Agenda Item # 6

SUB-003475-2025

The Cottages at Spring Hill Subdivision

- Subdivision approval to create seven (7) legal lot of record from one (1) existing legal lot of record.

DETAIL SITE PLAN

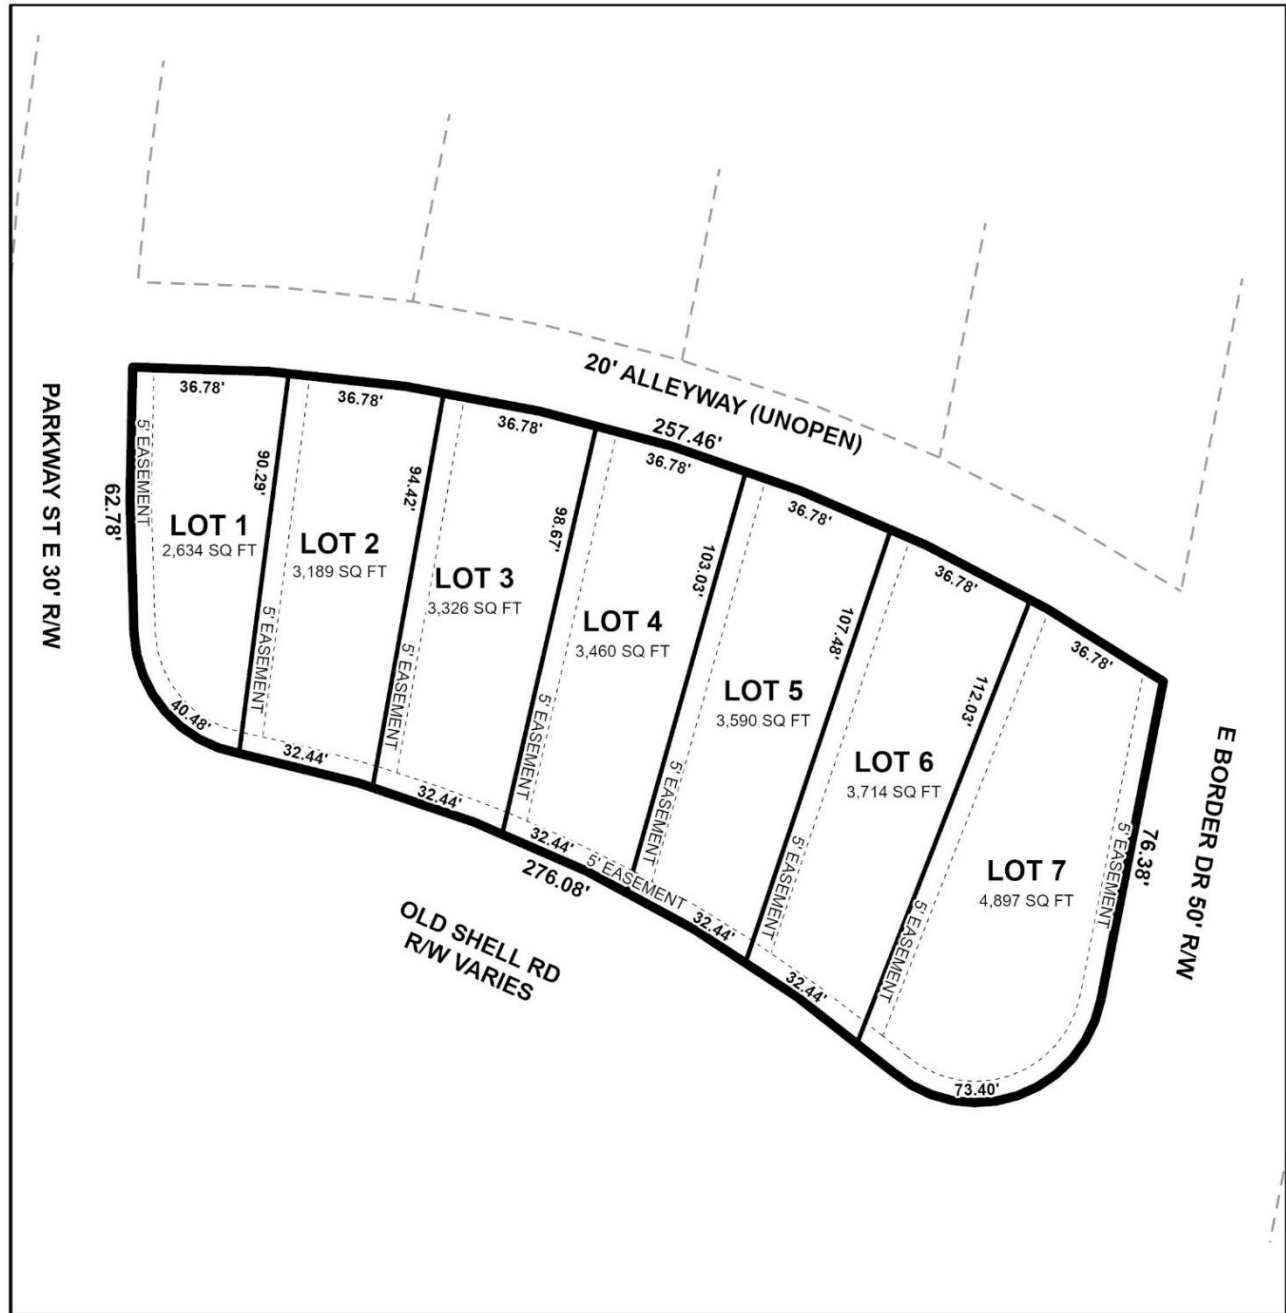
- B. Check the proposed Subdivision Name. The application indicates SPRING HILL COTTAGES and the drawing indicates COTTAGES AT SPRING HILL.
- C. The PLAT submitted is listed as SHEET NO. 1 of 2. Provide a copy of SHEET 2 of 2 for review.

- D. Correct the address in SURVEY NOTES #2 - from "...570..." to "...5070..."
- E. Based on the 1984 aerial photo LOTS 1-7 will share the 4,000 SF credit provided to the original lot. Applicant will need to coordinate with the City Engineering Permitting Department (G. Davis) to establish the exact amount that each Lot will receive prior to the submittal of the Final Plat for review.

- F. Applicant will need to provide information about the proposed stormwater detention for the subdivision. Without a common detention area each LOT owner will be required to provide their own detention pond.

The site has frontage along Old Shell Road, Parkway Street East, East Border Drive, and an alley. Old Shell Road, is a minor arterial street in this area, and as such, should have a right-of-way of 60-feet. It should be noted that the preliminary plat depicts the right-of-way as varying, so if approved the Final Plat should be revised to clearly depict that a minimum of 30-feet exists between the subject site and the centerline of Old Shell Road. Parkway Street East is a minor street without curb and gutter, and as such, should have a right-of-way of 60-feet. The preliminary plat submitted depicts the existing right-of-way as being 50-feet, therefore dedication to provide 30-feet from the

centerline of Parkway Street East should be required, if approved. East Border Drive is a minor street without curb and gutter, and as such, should have a right-of-way of 60-feet. The preliminary plat submitted depicts the existing right-of-way as being 50-feet, therefore dedication to provide 30-feet from the centerline of East Border Drive should be required, if approved. The alley has an existing compliant 20-foot right-of-way, and should be retained on the Final Plat, if approved. It should be noted that the SHO requires lots less than 65-feet in width to have a rear alley, and each of the proposed lots is less than 63-feet wide, therefore the lots are in compliance with this requirement.

The 25-foot maximum building setback line is not depicted along any of the street frontages. If approved, it should be depicted along all street frontages, adjusted for dedication, with the exception of the alley. It should be noted that the SHO allows for no required side yard setback and a five-foot (5') minimum rear yard setback. To reduce confusion, it is recommended that the setbacks be removed from the "Site Data Table".

The preliminary site plan submitted depicts a five-foot (5') private drainage and building maintenance easement along the proposed shared lot lines, as well as an eight-foot (8') private drainage easement along Old Shell Road, Parkway Street East, and East Border Drive. Therefore, a note should be required on the Final Plat, if approved, stating that no structure shall be constructed or placed within any easement without the permission of the easement holder.

1. Revision of the plat to depict that a minimum of 30-feet exists between the subject site and the centerline of Old Shell Road;
2. Dedication to provide 30-feet from the centerline of Parkway Street East;
3. Dedication to provide 30-feet from the centerline of East Border Drive;

4. Illustration of the 25-foot maximum building setback line along all street frontages on the Final Plat, excluding the alley, as measured from any required right-of-way dedication;

7. Revision of the plat to remove setbacks from the "Site Data Table";
8. Placement of a note stating that no structures exceeding three (3) stories tall may be erected;
